STAFF RECOMMENDATION

2236 Lindell Avenue

July 21, 2021

Application: New Construction-Infill

METRO PLOT PLAN

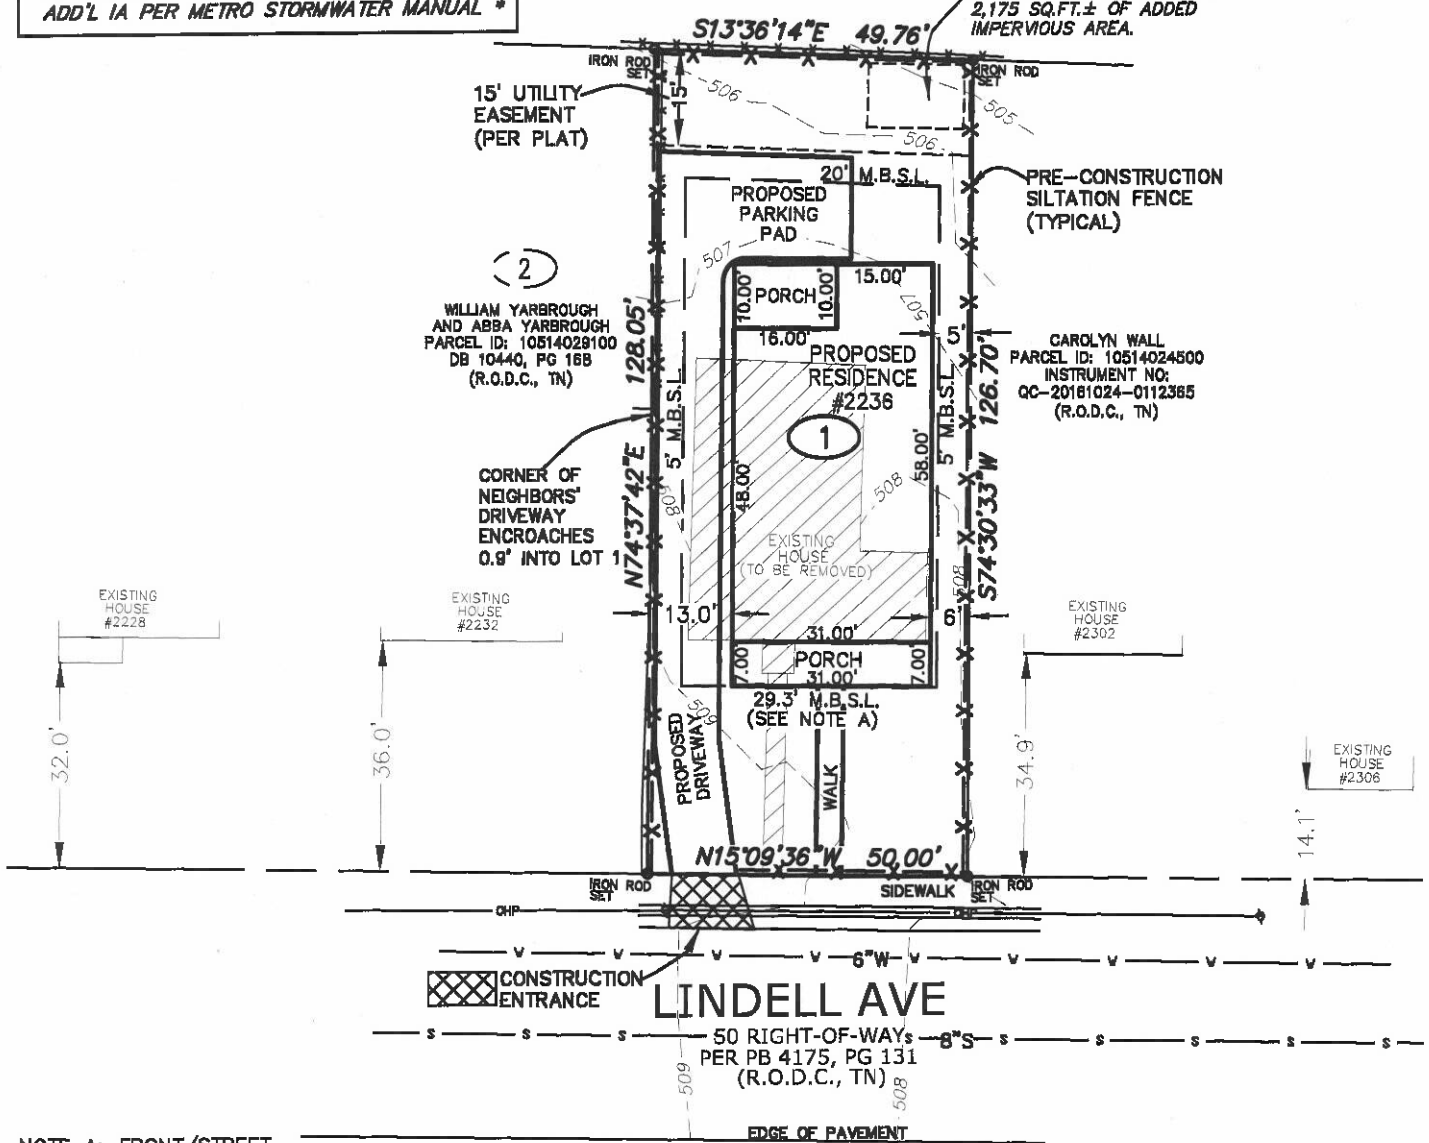
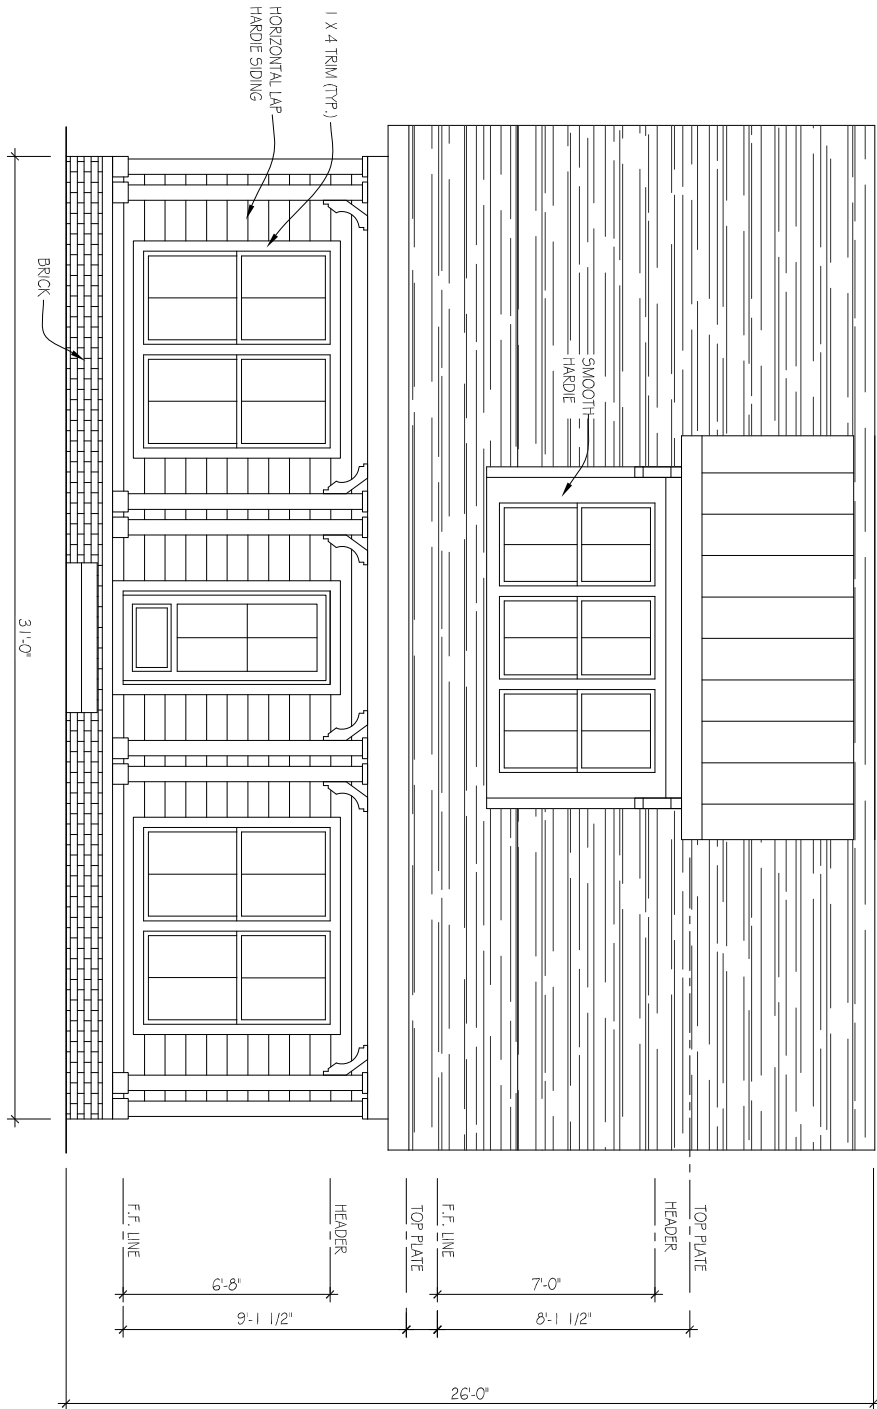
Setback & Rhythm of Spacing: The proposed infill meets all base zoning setbacks. It will be five feet (5') or more from each of the side property lines, and more than twenty feet (20') from the rear property line. However, the front porch edge does not align with the front porch edge of 2224 Lindell Avenue, the other infill proposed for this street, only a couple of houses down. Most of the surrounding homes are non-contributing and the front setback varies for the contributing homes that do exist on this side of the street. Staff finds that the front setback for the two new infill projects, 2224 and 2236 Lindell should align, thereby, establishing the setback for all future projects on this street. Staff finds the front setback should be determined by the setback that is most common to the other contributing homes on this side of Lindell Ave at 2308 Lindell through 2314 Lindell.

1. Alignment of the front setbacks of 2224 and 2236 Lindell; the new established setback should be determined by the setback that is most common to the contributing buildings at 2308-2314 Lindell Avenue.
2. Staff approve masonry samples;
3. Staff approve all windows and doors prior to purchase and installation;
4. Staff approve the roof material and color;
5. Staff approve cladding material, texture, and color;
6. The HVAC shall be located behind the house or on either side, beyond the midpoint of the house;
7. Utility meters shall be located on the side of the building, within 5' of the front corner or on the rear or rear-side within 5' of the rear corner; and,
8. Alternative mechanical and utility locations must be approved prior to an administrative sign-off on building permit.

FRONT ELEVATION

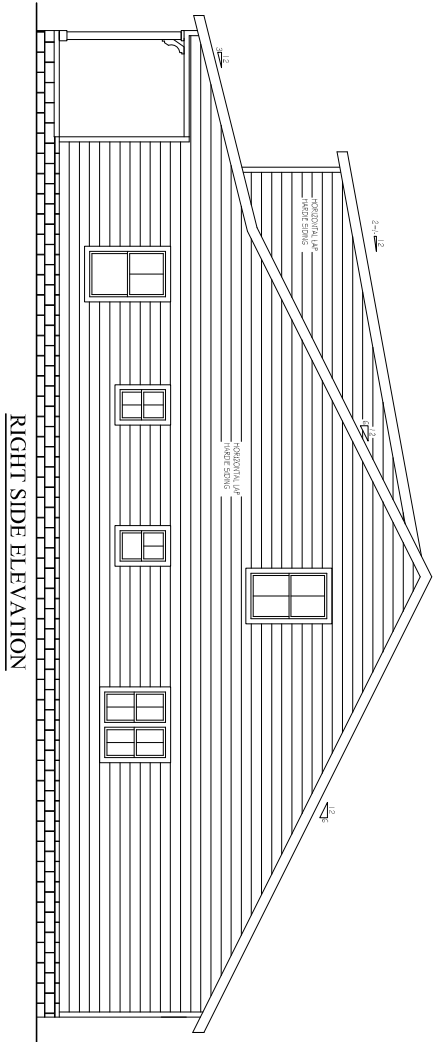
*Siding is shown as a lap siding with corner boards but the reveal was not indicated. In addition to review of the material, staff recommends that the reveal not exceed five inches (5"). Staff recommends that the siding be smooth, without an embossed grain.

Staff recommends that paired windows have a 4"-6" mullion between.

Roof form: The proposed primary roof form is a side gable roof with a 6/12 slope and a front dormer with a 2/12 slope. Side gable roofs are a common roof form on contributing homes of the Woodland-in-Waverly district and the pitch meets the minimum requirement for the district. Therefore, staff finds that the proposed roof form meets section III.B.2.e of the design guidelines.

Staff recommends approval of masonry, all windows and doors, the roof material and color, cladding material and color prior to purchase and installation. With staff's final approval of all final material choices, staff finds that the infill's materials meet Section III.B.2.d of the design guidelines.
